Hume Coal and Berrima Rail Project

Response to the Independent Planning Commission Assessment Report dated 27 May 2019

Prepared for Hume Coal Pty Ltd
April 2020

Figure 5.6 Groundwater inflow to open cut or underground workings –comparison between Hume Coal and other projects

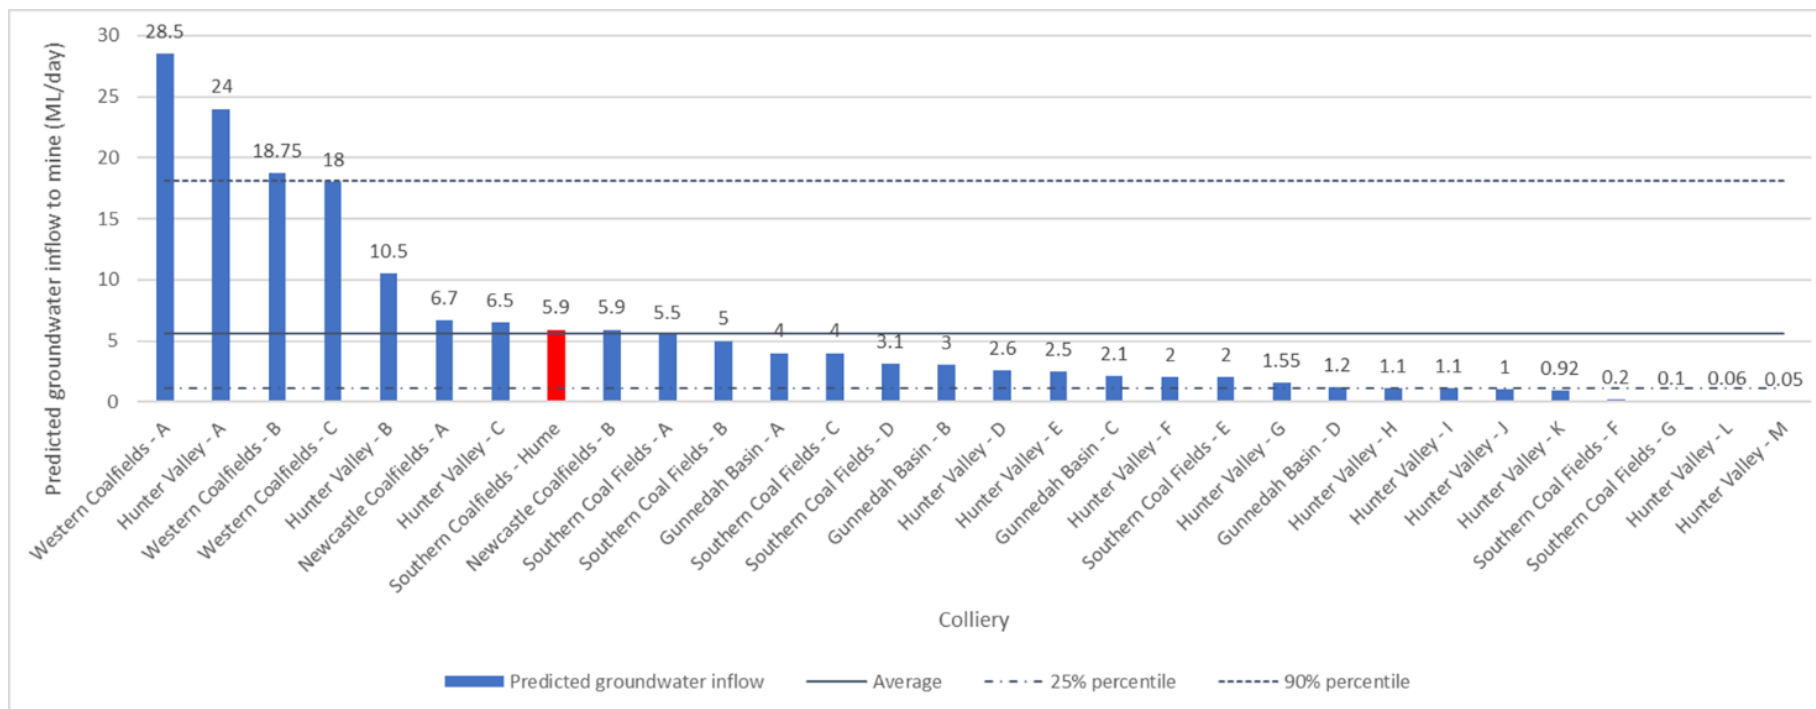
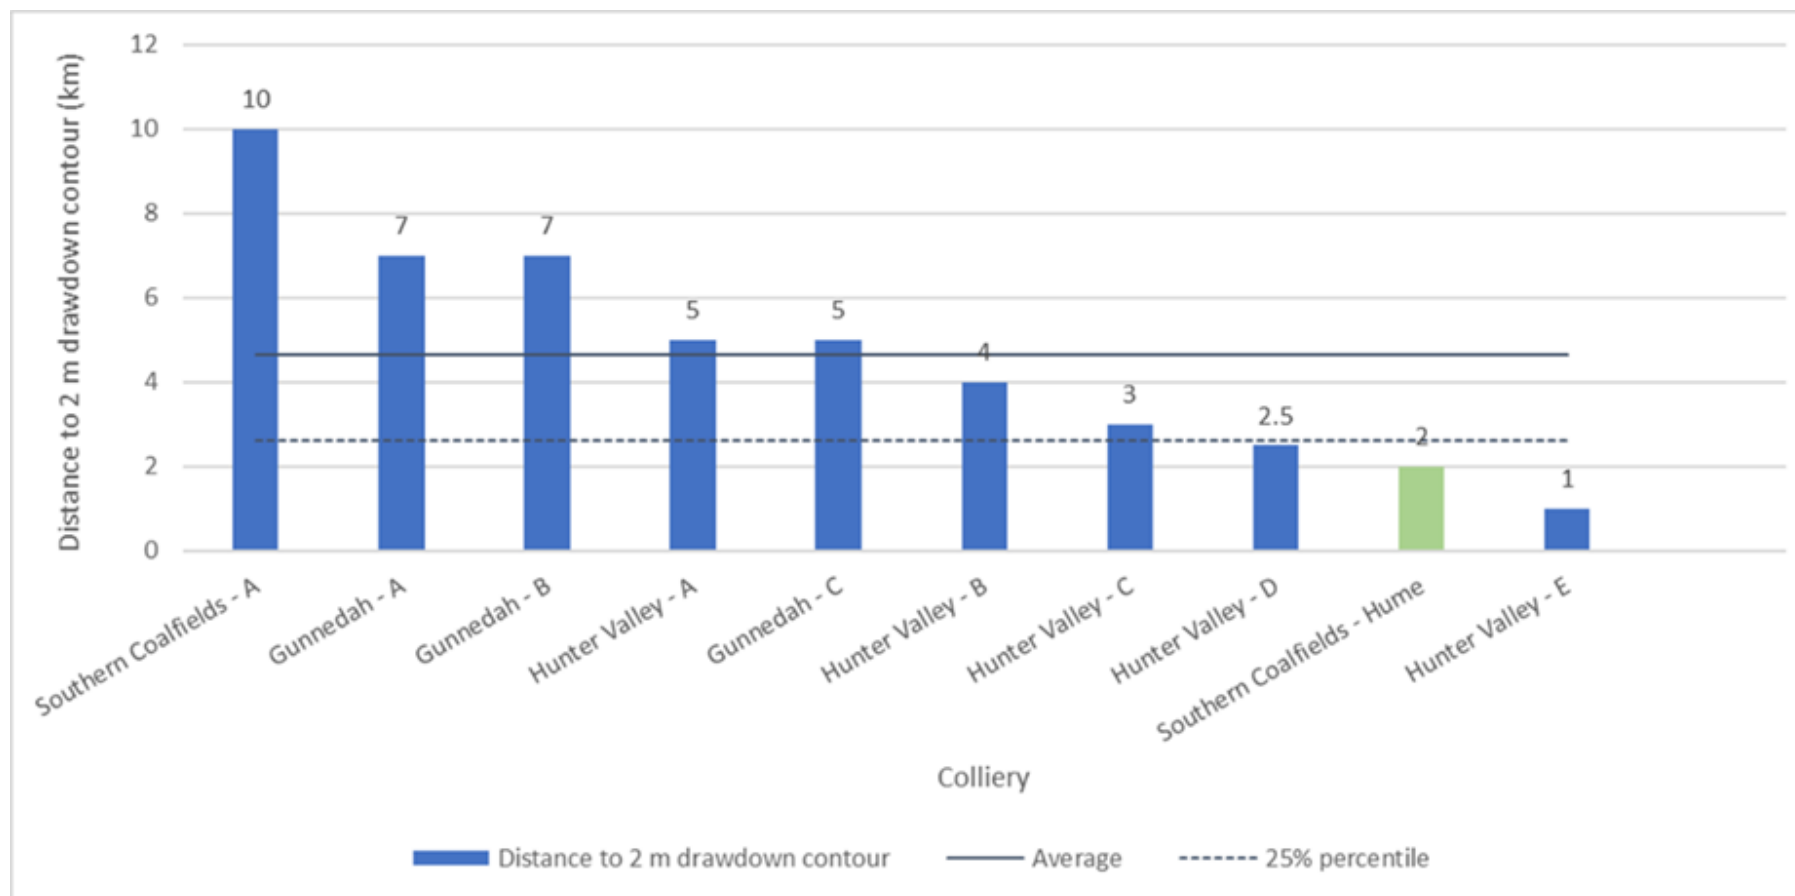
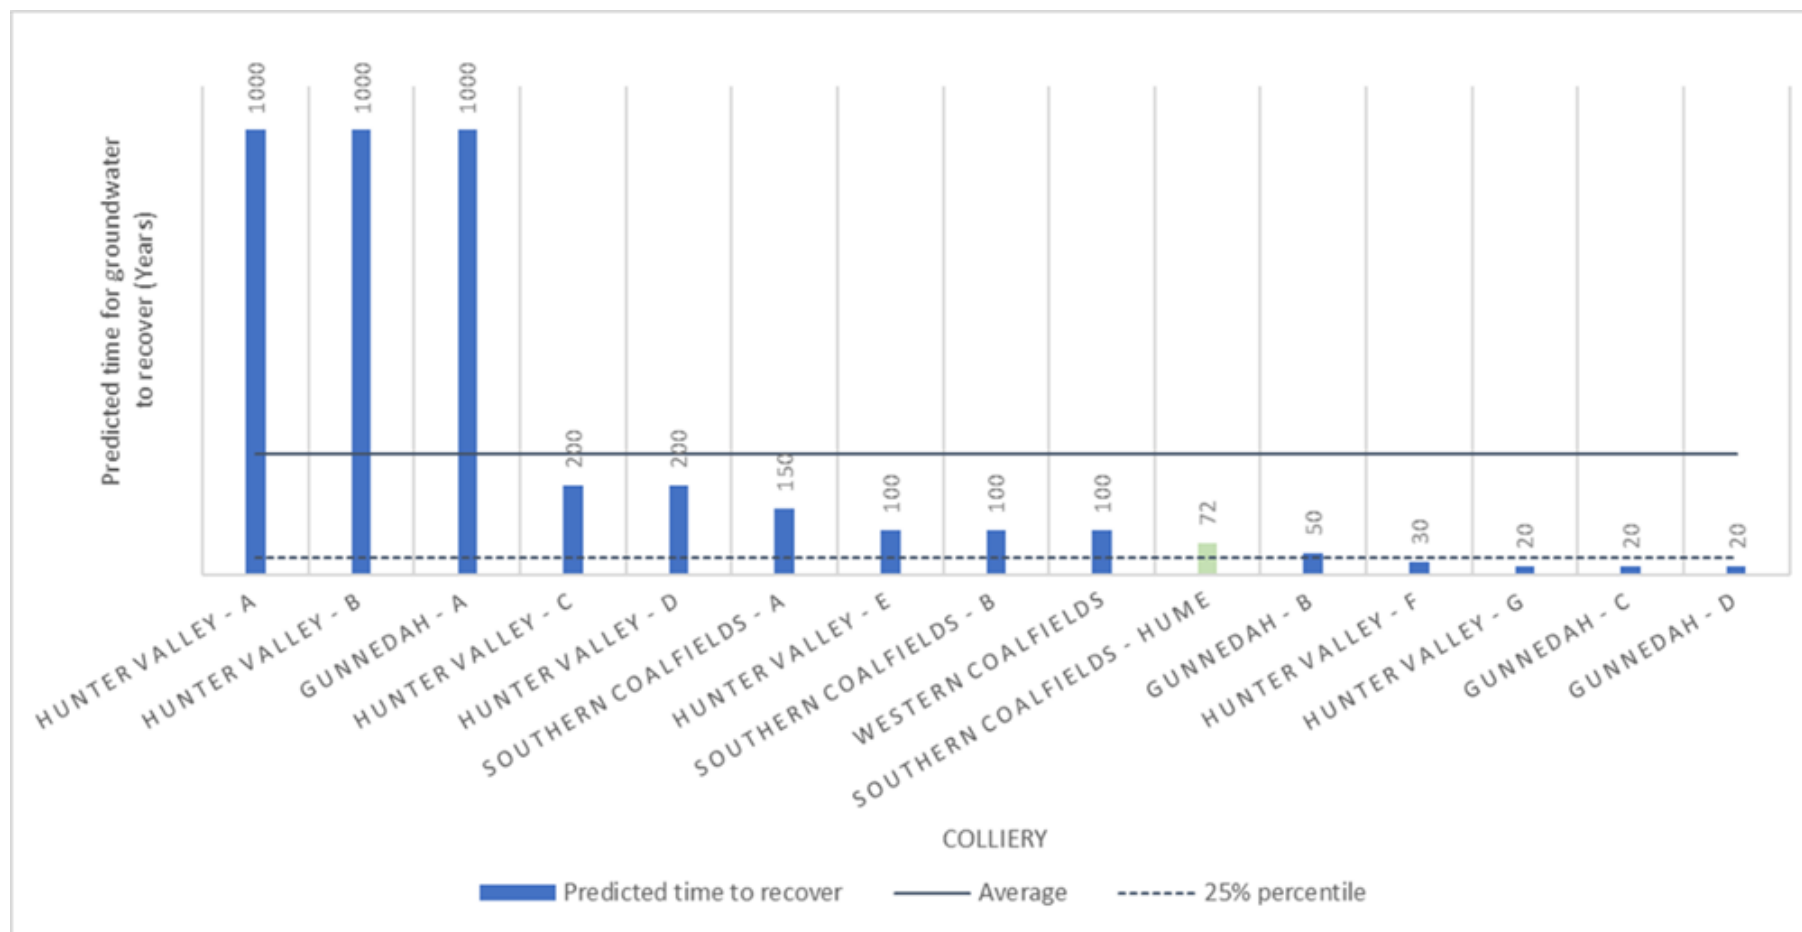
Reference number	IPC recommendations	Summary response
R5	<p>Because the Applicant and Department of Industry - Water remain a considerable distance apart regarding their positions on the groundwater modelling, the Commission suggests that the Department or the Applicant, or both of them jointly (and in any case in consultation with Department of Industry - Water), engage a new independent expert (or alternatively a small technical group with Chair) with experience in groundwater modelling with a view to resolving ongoing differences of opinion. The independent expert/Chair should consider:</p> <ul style="list-style-type: none"> • what practical steps, if any, can be taken to make the model a class 2 model or seek agreement on the class of the model; • what additional work is required to establish the extent to which the emplacement of water in mined-out voids will reduce the level of drawdown in the later years of the project; • the range used for the input parameters in the modelling sensitivity/uncertainty analysis and recommend if a wider range is required so that there is no unreasonable truncation of results; and • if additional geological information is required. 	<p>Hume Coal engaged Dr Lloyd Townley of GW-SW Pty Ltd to conduct an independent review of the groundwater modelling.</p> <p>Townley (2020) concluded that modelling undertaken for the Hume Coal Project is fit for purpose, for the purpose of predicting groundwater inflows to the proposed mine and drawdown of the water table within and near the Project area. This conclusion is consistent with the previous expert reviews by HydroAlgorithmics Pty Ltd (2016), Kalf and Associates Pty Ltd (2016) and HydroGeoLogic (2017, 2018) on behalf of DPE that concluded the original EIS model and subsequently the Modified EIS Model (RTS model) were fit for purpose. Townley (2020) concludes that the model is a Class 2 model, and has some elements of a Class 3 model.</p>

- the predicted peak annual inflow to Hume Coal mine is equivalent to the average inflow from a group of 29 mines;
- the predicted maximum extent of the 2 m drawdown contour at Hume (2 km) is less than half the average 2 m drawdown extent (4.7 km) from a group of 10 mines; and
- the predicted time for groundwater recovery back to 2 m at the Hume Coal Project is less than a fourth of the average from a group of 15 mines.

Figure 5.6 to Figure 5.8 present a comparison between the Hume Coal and other NSW coal mines related to predicted impacts related to mine inflows, predicted area of 2 m drawdown extent and predicted time to recovery.
